AMERICANS WITH DISABILITY ACT (ADA) FACILITY ASSESSMENT REPORT

Americans with Disabilities Act (ADA) Facility Barrier Report

For Selected Park Sites

July 2024

Red Sunset Park

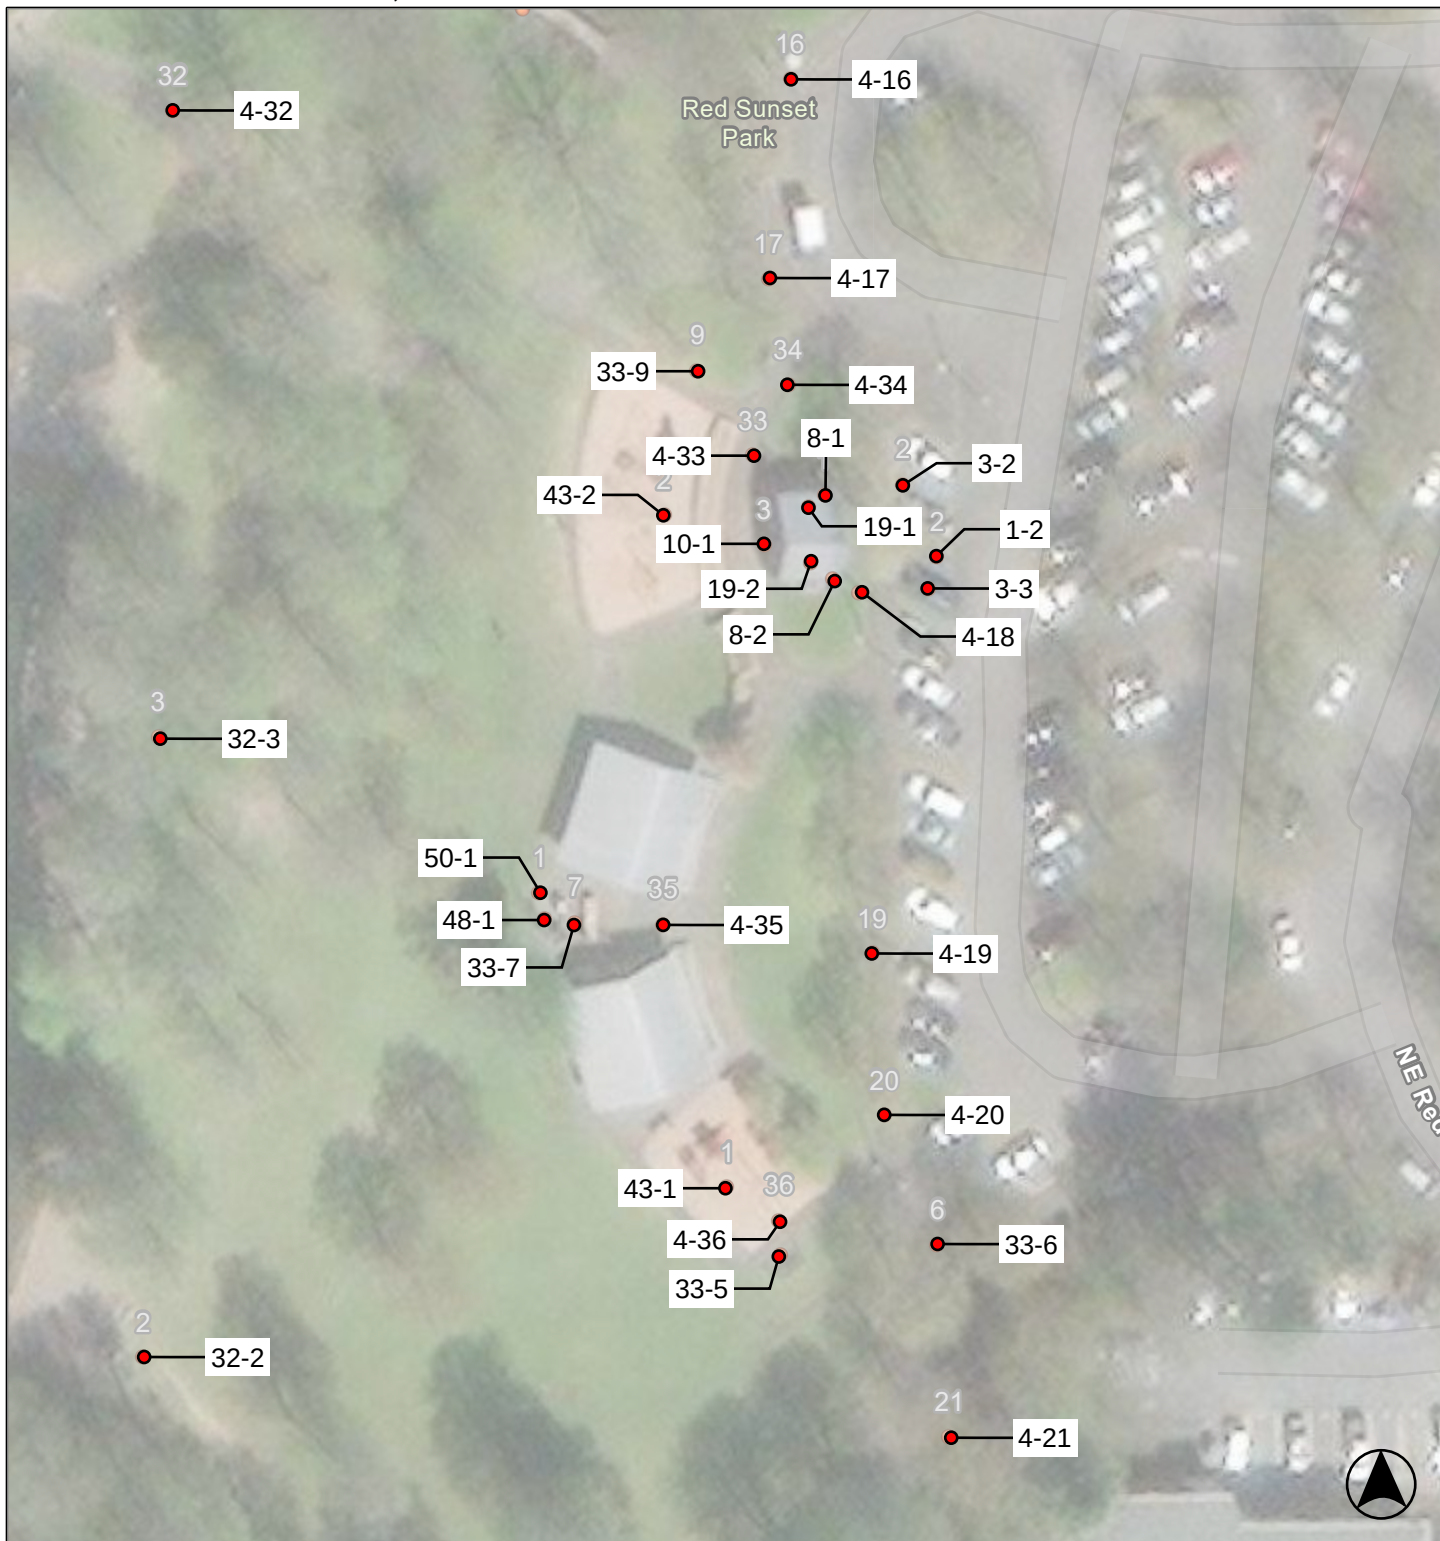
Park		
1 - 1	Parking Area	Category: 1
Install van accessible sign		\$1,750
Notes: A "Van Accessible" sign is not provided ("Van Accessible" sign that is 18" wide by 9" high on a white retroreflective background and green retroreflective lettering provided at each van accessible space).		
ADA: 208.2.4, 502.6		
Other: OSSC 1106.7		
Regrade accessible parking space or access aisle		\$4,050
Notes: Slopes of accessible parking space and access aisle are up to 2.9% (2.0% max).		
ADA: 502.4		
Other: -		
Provide adequate striping		\$180
Notes: The words "No Parking" are not painted in the access aisle.		
ADA: -		
Other: OSSC 1106.7		
1 - 2	Parking Area	Category: 1
Install van accessible sign		\$1,750
Notes: A "Van Accessible" sign is not provided ("Van Accessible" sign that is 18" wide by 9" high on a white retroreflective background and green retroreflective lettering provided at each van accessible space).		
ADA: 208.2.4, 502.6

Other: OSSC 1106.7		
Regrade accessible parking space or access aisle		\$4,050
Notes: Slopes of accessible parking space and access aisle are up to 3.4% (2.0% max).		
ADA: 502.4		
Other: -		
Provide adequate striping		\$180
Notes: The words "No Parking" are not painted in the access aisle.		
ADA: -		
Other: OSSC 1106.7		
Provide a pavement stencil		\$310
Notes: International symbol of accessibility pavement stencil is not provided. (28" high min, 24" wide min, painted with a 3" min stroke width of retroreflective white paint on an optional blue retroreflective background). ISA provided is faded and not retroreflective.		
ADA: -		
Other: OSSC 1106.7

Park		
3 - 1	Curb Ramp	Category: 1
Grind or patch vertical change of grade		\$320
Notes: Curb ramp has a surface level change of 3/4" due to at transition (curb ramp must be free of level changes).		
ADA: 405.4		
Other: -		
Install, replace or modify curb ramp		\$17,150
Notes: Slope of the curb ramp is 8.8% (8.33% max).		
ADA: 405.2, 406.1		
Other: -		
Provide detectable warnings		\$1,270
Notes: Detectable warning surface does not contrast visually with adjacent walking surfaces (light-on-dark or dark-on-light).		
ADA: 705.1		
Other: -		
Reduce or eliminate opening		\$300
Notes: A horizontal gap across the ramp is greater than 1/2" wide (1/2" max).		
ADA: 302.3		
Other: -		
3 - 2	Curb Ramp	Category: 1
Reduce or eliminate opening		\$300
Notes: A horizontal gap across the ramp is 1" wide (1/2" max).		
ADA: 302.3		
Other: -		
Provide detectable warnings		\$1,270
Notes: Detectable warning surface does not contrast visually with adjacent walking surfaces (light-on-dark or dark-on-light).

Park		
3 - 3	Curb Ramp	Category: 1
Reduce or eliminate opening		\$300
Notes: A horizontal gap across the ramp is 1" wide (1/2" max).		
ADA: 302.3		
Other: -		
Provide detectable warnings		\$1,270
Notes: Detectable warning surface does not contrast visually with adjacent walking surfaces (light-on-dark or dark-on-light).		
ADA: 705.1		
Other: -		
4 - 1	Walk	Category: 1
Regrade surface		\$4,700
Notes: Running slope of concrete is up to 7.1% for 47 linear feet (5.0% max).		
ADA: 403.3		
Other: -		
4 - 2	Walk	Category: 1
Reduce or eliminate opening		\$300
Notes: Gap at cracks in concrete is greater than 1/2" (1/2" max).		
ADA: 302.3		
Other: -		
4 - 3	Walk	Category: 1
Reduce or eliminate opening		\$300
Notes: Gap at cracks in concrete is greater than 1/2" (1/2" max).		
ADA: 302.3		
Other: -		
4 - 4	Walk	Category: 1
Reduce or eliminate opening		\$300
Notes: Gap at cracks in concrete is greater than 1/2" (1/2" max).		
ADA: 302.3

Park		
4 - 26	Walk	Category: 1
Regrade surface		\$8,100
Notes: Cross slope of concrete is up to 6.6% for 81 linear feet (2.0% max).		
ADA: 403.3		
Other: -		
Grind or patch vertical change of grade		\$100
Notes: Surface level change in path is greater than 1/4" (1/4" max; up to 1/2" with a 1:2 bevel)		
ADA: 303.2, 303.3		
Other: -		
4 - 27	Walk	Category: 1
Reduce or eliminate opening		\$600
Notes: Gap at cracks in concrete is greater than 1" (1/2" max).		
ADA: 302.3		
Other: -		
Regrade surface		\$5,000
Notes: Cross slope of concrete is up to 4.7% for 50 linear feet (2.0% max).		
ADA: 403.3		
Other: -		
4 - 28	Walk	Category: 1
Reduce or eliminate opening		\$600
Notes: Gap at cracks in concrete is greater than 1" (1/2" max).		
ADA: 302.3		
Other: -		
Grind or patch vertical change of grade		\$200
Notes: Surface level change is greater than 1/4" due to cracks (1/4" max; up to 1/2" with a 1:2 bevel).		
ADA: 303.2, 303.3

Park		
4 - 30	Walk	Category: 1
Reduce or eliminate opening		\$600
Notes: Gap at cracks in concrete is greater than 1/2" (1/2" max).		
ADA: 302.3		
Other: -		
4 - 31	Walk	Category: 1
Regrade surface		\$9,200
Notes: Running slope of path to bridge is up to 7.1% (5.0% max).		
On the bridge, the run slope was up to 6.5% and cross slope of 4.3% (2.0% max).		
Total segment length for 92 linear feet.		
ADA: 403.3		
Other: -		
Grind or patch vertical change of grade		\$100
Notes: Surface level change in path is greater than 1/4" (1/4" max; up to 1/2" with a 1:2 bevel)		
ADA: 303.2, 303.3		
Other: -		
4 - 32	Walk	Category: 1
Regrade surface		\$13,200
Notes: Running slope of path from bridge is up to 10.5% (5.0% max). Cross slope on path of 4.3% (2.0% max).		
Total segment length is 132 linear feet.		
ADA: 403.3		
Other: -		
Grind or patch vertical change of grade		\$300
Notes: Surface level change in path is greater than 1/4" (1/4" max; up to 1/2" with a 1:2 bevel).

Surface level change on bridge is greater than 1" (1/4" max; up to 1/2" with a 1:2 bevel). (x2)		
ADA: 303.2, 303.3		
Other: -

Park		
4 - 33	Walk	Category: 1
Regrade surface		\$3,500
Notes: Cross slope of in front of the dedication plaque is up to 3.0% for 10 linear feet (2.0% max).		
Cross slope around the playground is up to 3.8% for 25 linear feet (2.0% max).		
ADA: 403.3		
Other: -		
Grind or patch vertical change of grade		\$100
Notes: Tripping hazard in the walkway (1/4" max; up to 1/2" with a 1:2 bevel)		
ADA: 303.2, 303.3		
Other: -		
Reduce or eliminate opening		\$2,400
Notes: Gap at concrete joint is greater than 1/2" (1/2" max). (x8)		
ADA: 302.3		
Other: -		
4 - 34	Walk	Category: 1
Regrade surface		\$1,000
Notes: Running slope of concrete is up to 5.5% for 10 linear feet (5.0% max).		
ADA: 403.3		
Other: -		
4 - 35	Walk	Category: 1
Reduce or eliminate opening		\$1,200
Notes: Gap at concrete joints in front of the sink and shelter is greater than 1/2" (1/2" max). (x4)		
ADA: 302.3		
Other: -		
4 - 36	Walk	Category: 1
Reduce or eliminate opening		\$300

Park		
8 - 1	Door/Gate	Category: 1
Provide or modify door kick plate		\$350
Notes: A smooth and uninterrupted kick plate surface is not provided. A doorstop is located in the 10" space above the finish floor.		
ADA: 404.2.10		
Other: -		
Adjust door closer		\$160
Notes: Door closer sweep time is less than the five second minimum from 90 degrees to 12 degrees.		
Door opening force is 8 lbs (5 lbs max).		
ADA: 404.2.8.1, 404.2.9		
Other: OSSC 1102.1.2.5		
Enlarge door opening		\$4,650
Notes: Height of clear opening is 77" AFF (80" min). The mag lock protrudes into the head clearance.		
ADA: 404.2.3		
Other: -		
Reduce or eliminate opening		\$300
Notes: Gaps and cracks in the the landing/threshold create openings greater than 1/2" (1/2" max).		
ADA: 302.3		
Other: -		
Provide strike edge clearance		\$3,180
Notes: The push side clearance is obstructed by the lightswitch box and is less than 8" (8" min).		
ADA: 404.2.4.3

Park		
8 - 2	Door/Gate	Category: 1
Provide or modify door kick plate		\$350
Notes: A smooth and uninterrupted kick plate surface is not provided. A doorstop is located in the 10" space above the finish floor.		
ADA: 404.2.10		
Other: -		
Adjust door closer		\$160
Notes: Door closer sweep time is less than the five second minimum from 90 degrees to 12 degrees.		
Door opening force is 12 lbs (5 lbs max).		
ADA: 404.2.8.1, 404.2.9		
Other: OSSC 1102.1.2.5		
Enlarge door opening		\$4,650
Notes: Height of clear opening is 78" AFF (80" min). The mag lock protrudes into the head clearance.		
ADA: 404.2.3		
Other: -		
Reduce or eliminate opening		\$300
Notes: Gaps and cracks in the the landing/threshold create openings of 5/8" (1/2" max).		
ADA: 302.3		
Other: -		
10 - 1	Drinking Fountain	Category: 3
Confirm water flow compliance		\$0
Notes: Water service to the drinking fountain was disconnected at the time of the assessment. Flow height and angle could not be confirmed.

ADA: 602.3, 602.6		
Other: -		
10 - 2	Drinking Fountain	Category: 3
Confirm water flow compliance		\$0
Notes: Water service to the drinking fountain was disconnected at the time of the assessment. Flow height and angle could not be confirmed.		
ADA: 602.3, 602.6		
Other: -		
Increase or provide maneuvering or clear floor area		\$1,270
Notes: The clear floor space has a greater than 1/2" gap in the pavement (1/2" max).		
ADA: 305.1, 305.2, 305.3, 305.5, 306.1		
Other: -

Park		
10 - 3	Drinking Fountain	Category: 3
Confirm water flow compliance		\$0
Notes: Water service to the drinking fountain was disconnected at the time of the assessment. Flow height and angle could not be confirmed.		
ADA: 602.3, 602.6		
Other: -		
Increase or provide maneuvering or clear floor area		\$1,270
Notes: The clear floor space has a trench drain with 5" slots, creating openings (1/2" max).		
ADA: 305.1, 305.2, 305.3, 305.5, 306.1		
Other: -

Park	
19 - 1	Multiple User Restroom Category: 2
Install restroom sign	\$250
Notes: A tactile and braille restroom sign is not provided. Women's restroom side.	
ADA: 216.2, 216.8	
Other: -	
Insulate water lines	\$160
Notes: The lavatory drain pipes are not insulated.	
ADA: 606.5	
Other: -	
Reposition clothing hooks	\$160
Notes: The coat hook in the accessible compartment is more than 48" AFF (48" max).	
ADA: 308.1	
Other: -	
Provide or replace compartment door hardware	\$550
Notes: Water closet compartment door is not self-closing.	
The door is not on the corner furthest from the water closet.	
ADA: 604.8.1.2	
Other: -	
Modify stall partitions	\$650
Notes: Clear width over water closet is 45" (60" min) to the wall.	
ADA: 604.3.1	
Other: -	
Reposition toilet flush controls	\$160
Notes: Flush control is not located on wide side of the water closet (flush control is required to be located on the open side of the fixture).

ADA: 604.6	
Other: -	
Replace or modify grab bars	\$480
Notes: A rear and vertical grab bar are not provided.	
The side grab bar is 41" long (42" min) and ends less than 54" from the rear wall (54" min).	
ADA: 604.5.1, 604.5.2	
Other: A117.1 604.5.1.2

Park		
19 - 1	Multiple User Restroom	Category: 2
Replace or reposition dispenser		\$160
Notes: The toilet paper is 7" above the side grab bar (12" min).		
ADA: 604.7		
Other: -		
Replace toilet or adjust toilet seat height		\$2,850
Notes: Water closet seat height is 19-1/2" AFF (17" min to 19" max).		
ADA: 604.4		
Other: -

Park	
19 - 2 Multiple User Restroom	Category: 2
Install restroom sign	\$250
Notes: A tactile and braille restroom sign is not provided. Men's restroom side.	
ADA: 216.2, 216.8	
Other: -	
Insulate water lines	\$160
Notes: The lavatory drain pipes are not insulated.	
ADA: 606.5	
Other: -	
Provide or replace compartment door hardware	\$550
Notes: Water closet compartment door does not interior or exterior handles.	
ADA: 604.8.1.2	
Other: -	
Modify stall partitions	\$650
Notes: Clear width over water closet is 47" (60" min) to the wall.	
ADA: 604.3.1	
Other: -	
Reposition toilet flush controls	\$160
Notes: Flush control is not located on wide side of the water closet (flush control is required to be located on the open side of the fixture).	
ADA: 604.6	
Other: -	
Replace or modify grab bars	\$480
Notes: A rear and vertical grab bar are not provided.	
The side grab bar extends to 53" from the rear wall (54" min).	
ADA: 604.5.1, 604.5.2

Other: A117.1 604.5.1.2	
Replace or reposition dispenser	\$160
Notes: The centerline of the toilet paper in front of the water closet is 13" (7" min and 9" max).	
ADA: 604.7	
Other: -	
Replace urinal	\$2,385
Notes: Height of the urinal rim is 19" AFF (17" max).	
ADA: 605.2	
Other: -

Park		
19 - 2	Multiple User Restroom	Category: 2
Replace or reposition fixtures		\$1,590
Notes: The centerline of the water closet is 18-1/2" from the wall (16" min to 18" max).		
ADA: 604.2		
Other: -		
Replace or adjust water controls		\$640
Notes: Water flows from the lavatory faucet for 4 seconds (10 seconds min).		
Operating effort of lavatory faucet is 8 lbs (5 lbs max).		
ADA: 309.1, 606.4		
Other: -		
29 - 1	Game and Sports Area	Category: 2
Provide wheelchair seating		\$3,600
Notes: No wheelchair spaces are provided near the approximately 50 spectator bleacher seats (2 wheelchair spaces min for 26 to 50 seats). (x2 sets of bleachers)		
ADA: 221.2.1.1		
Other: -		
Provide wheelchair seating		\$1,800
Notes: No wheelchair spaces provided in team seating areas (two min - one per team space).		
ADA: 221.2.1.4		
Other: -		
32 - 1	Picnic Area	Category: 2
Provide an accessible table		\$3,250
Notes: Knee clearance measured 8" horizontally from the front face of the table top is 25" (27" min).

ADA: -		
Other: ABA 306.3		
Increase or provide clear floor area		\$200
Notes: There is a 1" gap in the clear floor space of the picnic table (1/2" max).		
ADA: -		
Other: ABA 1011.2.1

Park		
32 - 2	Picnic Area	Category: 2
Provide an accessible route		\$6,400
Notes: An accessible route to the picnic table is not provided. Route is 80 linear feet over grass from the path to picnic area (36" wide min path of travel constructed with an accessible surface).		
ADA: -		
Other: ABA F206.2.2, ABA F245.4		
32 - 3	Picnic Area	Category: 2
Provide an accessible route		\$6,400
Notes: An accessible route to the picnic table is not provided. Route is 80 linear feet over grass from the path to picnic area (36" wide min path of travel constructed with an accessible surface).		
ADA: -		
Other: ABA F206.2.2, ABA F245.4		
Provide an accessible table		\$3,250
Notes: Knee clearance measured 8" horizontally from the front face of the table top is 26" (27" min).		
ADA: -		
Other: ABA 306.3		
32 - 4	Picnic Area	Category: 2
Provide an accessible route		\$1,600
Notes: An accessible route to the picnic table is not provided. Route is 20 linear feet over grass from the path to picnic area (36" wide min path of travel constructed with an accessible surface).

ADA: -		
Other: ABA F206.2.2, ABA F245.4		
Provide an accessible table		\$3,250
Notes: Knee clearance measured 8" horizontally from the front face of the table top is 26" (27" min).		
ADA: -		
Other: ABA 306.3		
Increase or provide clear floor area		\$200
Notes: The clear space around the grill narrows down to 24" (48" min wide).		
ADA: -		
Other: ABA 1011.2.1		
Regrade surface		\$20
Notes: Slope of the clear floor space around the grill is up to 3.9% (2.0% max).		
ADA: -		
Other: ABA 1011.2.3

Park		
32 - 5	Picnic Area	Category: 2
Provide an accessible table		\$3,250
Notes: Knee clearance measured 8" horizontally from the front face of the table top is 26" (27" min).		
ADA: -		
Other: ABA 306.3		
Increase or provide clear floor area		\$200
Notes: The clear space around the grill narrows down to 24" (48" min wide).		
ADA: -		
Other: ABA 1011.2.1		
33 - 1	Outdoor Constructed Features	Category: 3
Increase or provide clear floor area		\$200
Notes: A clear ground space is not provided adjacent to the bench (36" by 48" min).		
ADA: -		
Other: ABA 1011.2.1, ABA 1011.2.3		
33 - 2	Outdoor Constructed Features	Category: 3
Increase or provide clear floor area		\$200
Notes: A clear ground space is not provided adjacent to the bench (36" by 48" min).		
ADA: -		
Other: ABA 1011.2.1, ABA 1011.2.3		
33 - 3	Outdoor Constructed Features	Category: 3
Increase or provide clear floor area		\$200
Notes: There is a greater than 1/2" gap in the pavement in front of the trash container (1/2" max).

ADA: -		
Other: ABA 1011.2		
33 - 4	Outdoor Constructed Features	Category: 3
Increase or provide clear floor area		\$200
Notes: There is a greater than 1" gap between the bench and the trash container (1/2" max).		
ADA: -		
Other: ABA 1011.2		
33 - 5	Outdoor Constructed Features	Category: 3
Increase or provide clear floor area		\$200
Notes: A clear ground space is not provided adjacent to the bench (36" by 48" min). Space is too narrow.		
ADA: -		
Other: ABA 1011.2.1, ABA 1011.2.3

Park		
33 - 6	Outdoor Constructed Features	Category: 3
Increase or provide clear floor area		\$200
Notes: Clear ground space adjacent to the bench has a slope of 3.7% (2.0% max).		
ADA: -		
Other: ABA 1011.2.1, ABA 1011.2.3		
33 - 7	Outdoor Constructed Features	Category: 3
Replace or reposition picnic grill		\$950
Notes: Cooking surface is 40" above the ground (34" max).		
ADA: -		
Other: ABA 1011.5.2		
33 - 8	Outdoor Constructed Features	Category: 3
Increase or provide clear floor area		\$200
Notes: Clear ground space adjacent to the trash can has a slope of 3.7% (2.0% max).		
ADA: -		
Other: ABA 1011.2.1, ABA 1011.2.3		
33 - 9	Outdoor Constructed Features	Category: 3
Increase or provide clear floor area		\$200
Notes: A clear ground space is not provided adjacent to the bench (36" by 48" min).		
ADA: -		
Other: ABA 1011.2.1, ABA 1011.2.3		
35 - 1	Other	Category: 3
Reposition controls		\$285
Notes: Operating mechanism of dog bag station is 52" above the ground (15" min to 48" max). Dispenser is out of reach range.

ADA: 308.2, 308.2.1		
Other: -		
35 - 2	Other	Category: 3
Reposition controls		\$285
Notes: The horizontal reach range is 60" over grass (24" max horizontal reach).		
ADA: 308.2.2		
Other: -		
35 - 3	Other	Category: 3
Increase or provide maneuvering or clear floor area		\$200
Notes: Clear floor space of the dog bag stations is not provided (30" by 48" min).		
ADA: 305.2, 305.3, 305.5		
Other: -

Park		
35 - 4	Other	Category: 3
Reposition controls		\$285
Notes: Operating mechanism of the dog bag station is 56" above the ground (15" min to 48" max).		
The reach is 32" horizontally and out of reach range (24" max).		
ADA: 308.2, 308.2.1		
Other: -		
43 - 1	Play Equipment Area	Category: 2
Improve or evaluate play area surface		\$0
Notes: Ground surface in play area is in need of maintenance and further evaluation of fall attenuation surface is recommended.		
ADA: 1008.2.6.1, 1008.2.6.2		
Other: -		
Regrade or replace ramp		\$540
Notes: The ramp runs connecting ground level play components within the play structure have a slope of 9.1% (6.25% max).		
ADA: 1008.2.5.1		
Other: -		
43 - 2	Play Equipment Area	Category: 2
Improve or evaluate play area surface		\$0
Notes: Ground surface in play area is in need of maintenance and further evaluation of fall attenuation surface is recommended.		
ADA: 1008.2.6.1, 1008.2.6.2

Other: -		
Install or modify transfer system		\$6,350
Notes: The transfer step is 8-1/2" high (8" max).		
ADA: 1008.3.2.1, 1008.3.2.2		
Other: -
